LEReC  
INSTRUMENTATION  
DEVELOPMENT

6-18-15

## Meeting Minutes

# Emittance Slit Mech Design

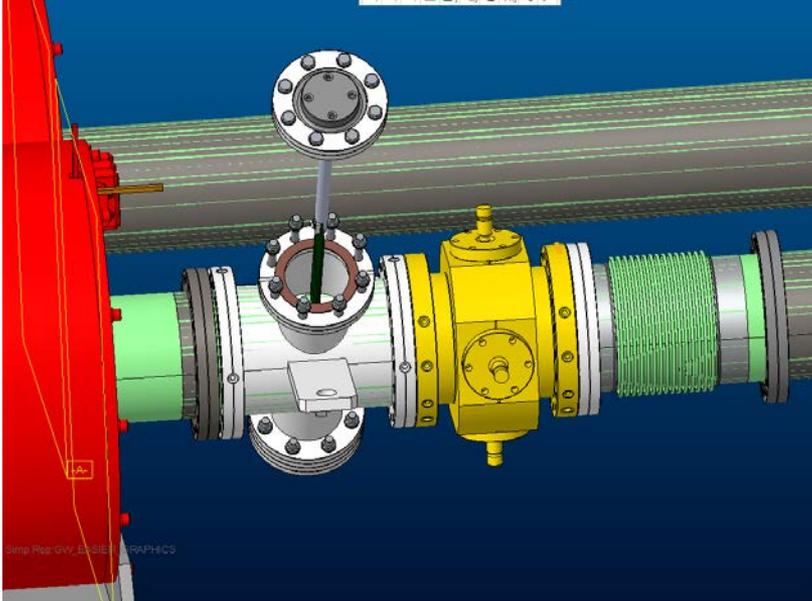
The attached picture shows the EMS in the beam line. The chamber length is specified in the general system spec. and the flanges are fixed. The scanner port does not allow for the bolts to be inserted from the scanner side into the BPM chamber. There are a number of options to consider.

1. Referring back to the attached picture, there appears to be enough room to increase the chamber length and permit bolt installation
2. use a rotatable flange on the scanner chamber and preinstall bolts into the flange and rotate the flange into position
3. maintain the fixed flange and preinstall the flange with studs prior to assembly
4. move the port off chamber center away from the BPM and adjust the scanner chamber support design.

Our preference is to increase the chamber length if permitted.

**Can we increase the length of the chamber by ~1 inch?  
(YES)**

Is there a specific location for the mask plane either relative to the lattice or to the profile monitor that must be maintained?

# Cooling BPM Design

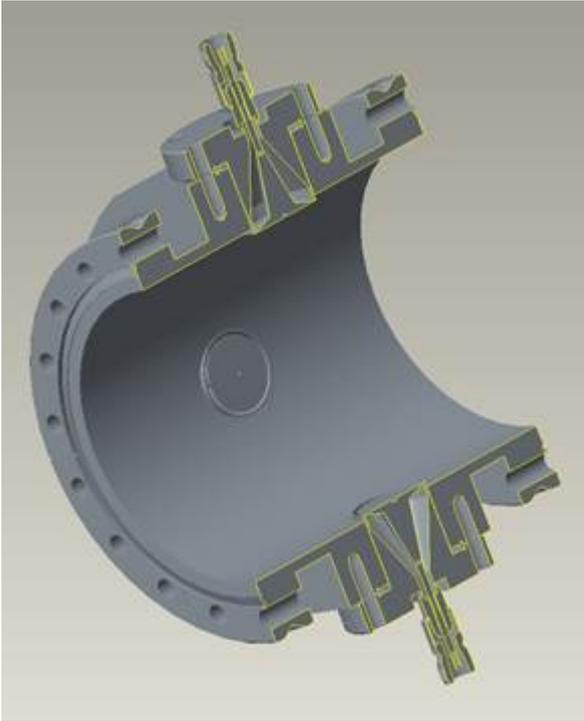
I've asked Vito to make two more drawings, each with min & max extreme tolerances that shows the full range of possible distances from the side of the button face to the adjacent housing aperture ID. Peter T has tentatively agreed to relax the  $+0.000/-0.004$  as long as the distance of opposing buttons to the beam line center is as accurate as possible ( $\pm 0.002$ ).

**Result range is recess of 0.030" and protrusion of 0.013"**

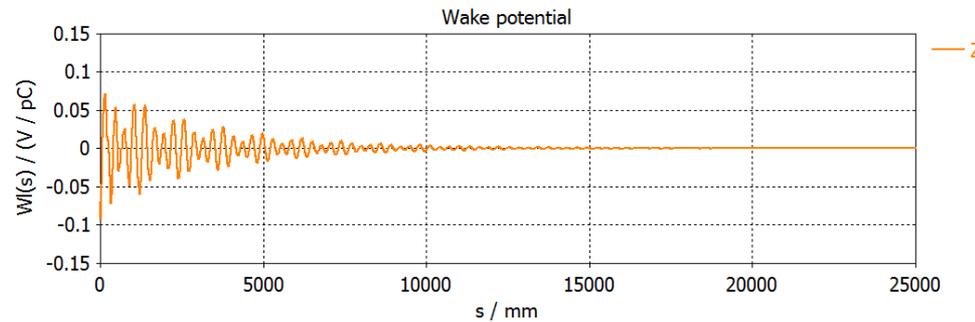
- These work better with one contact point on each side but this requires mechanical mods (disassembly, machining, cleaning, reassembly)
  - Is this benefit worth the expense?

# Modified BPM + YAG Study

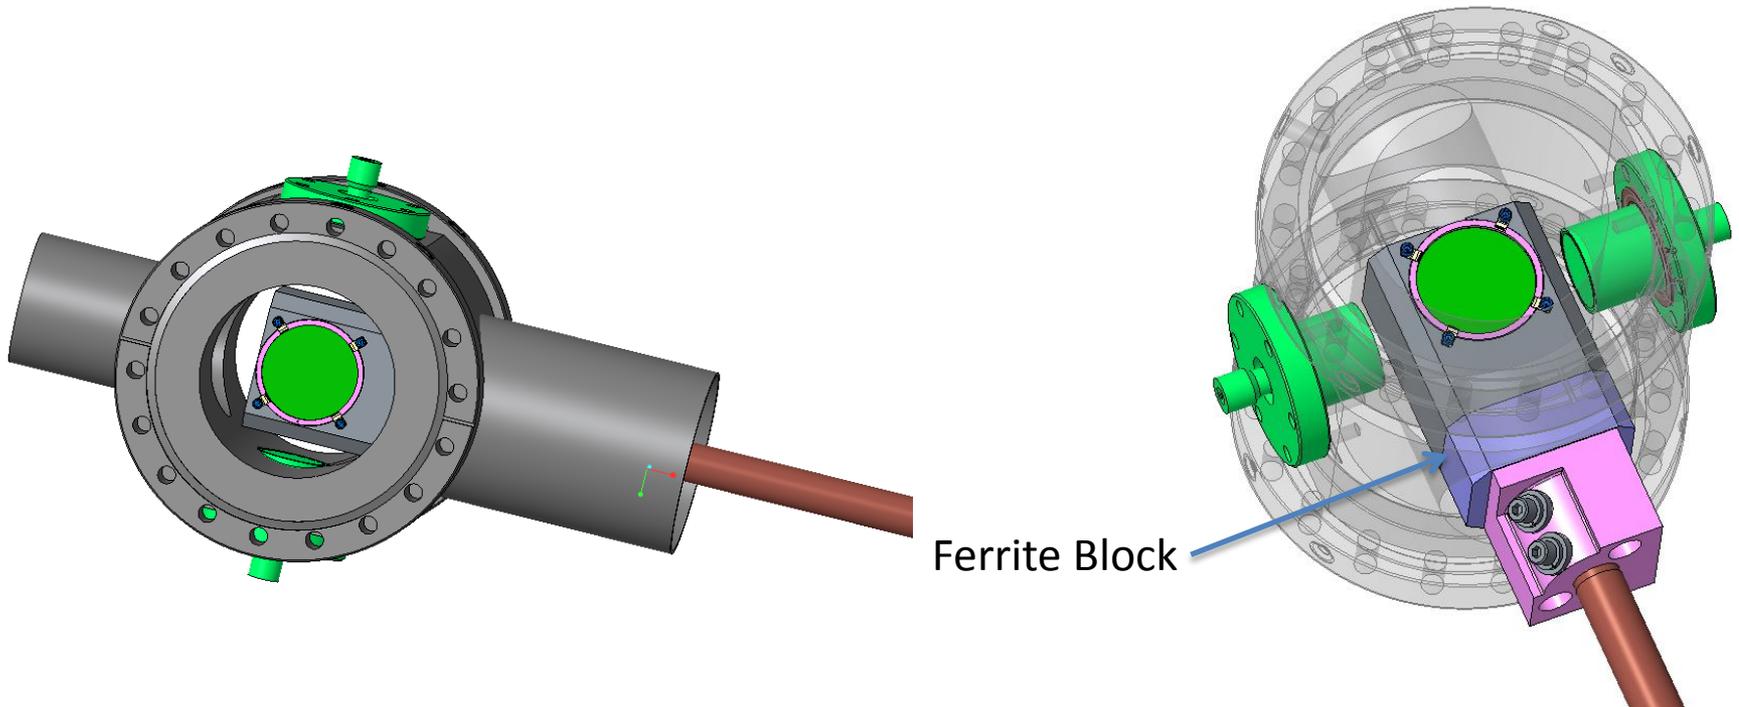
- Single plane BPM in smaller chamber
- 40mm YAG crystal actuated into chamber
- Preliminary design underway
- Impedance simulation pending

# Enhanced Energy Spread Measurement

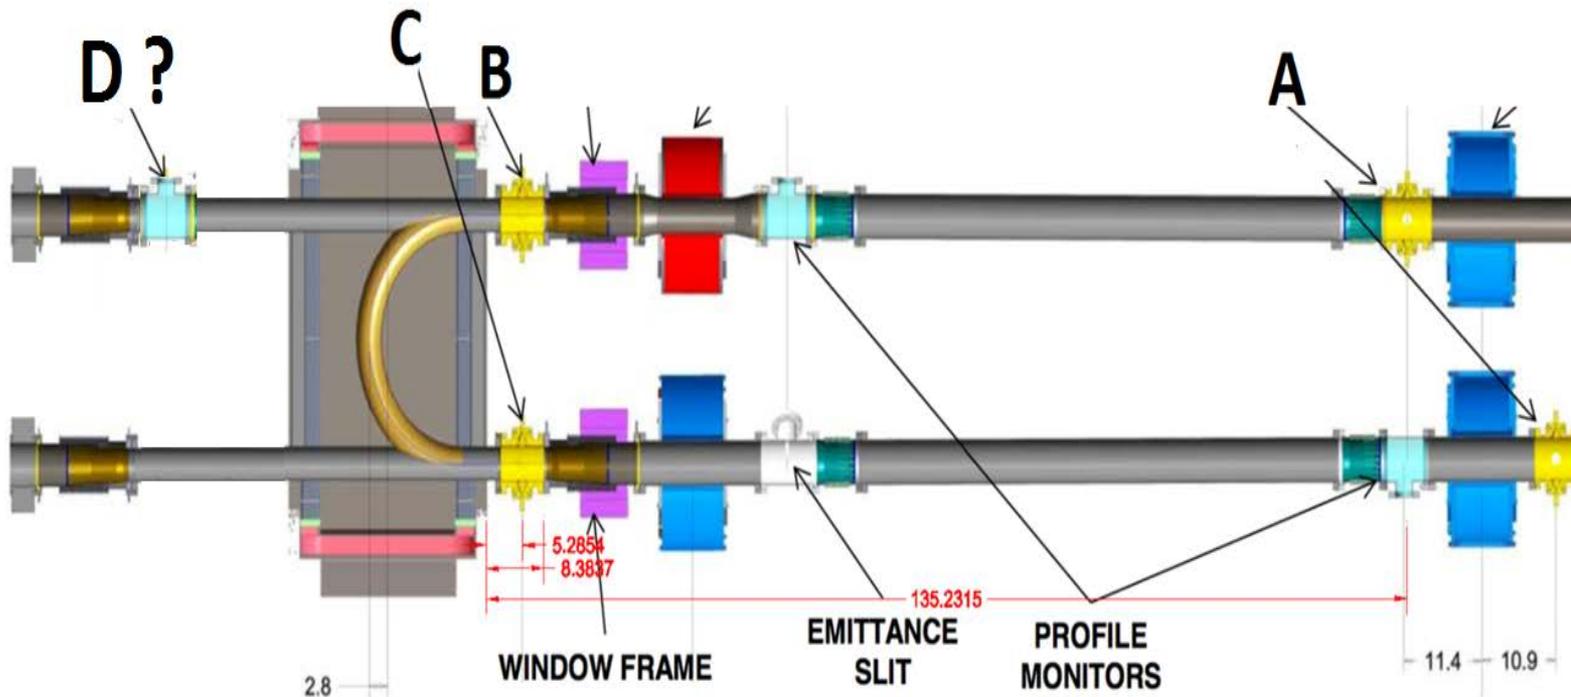
- 1) Install a slit on the YAG actuator in B
- 2) Install a profile monitor D at a distance BD equal to the trajectory length from B to C

A better energy measurement would result with a smaller image at C  
A better energy spread measurement would result by comparing beam spot widths at D and C. The red solenoid would not need to be strong and could have steering correctors.
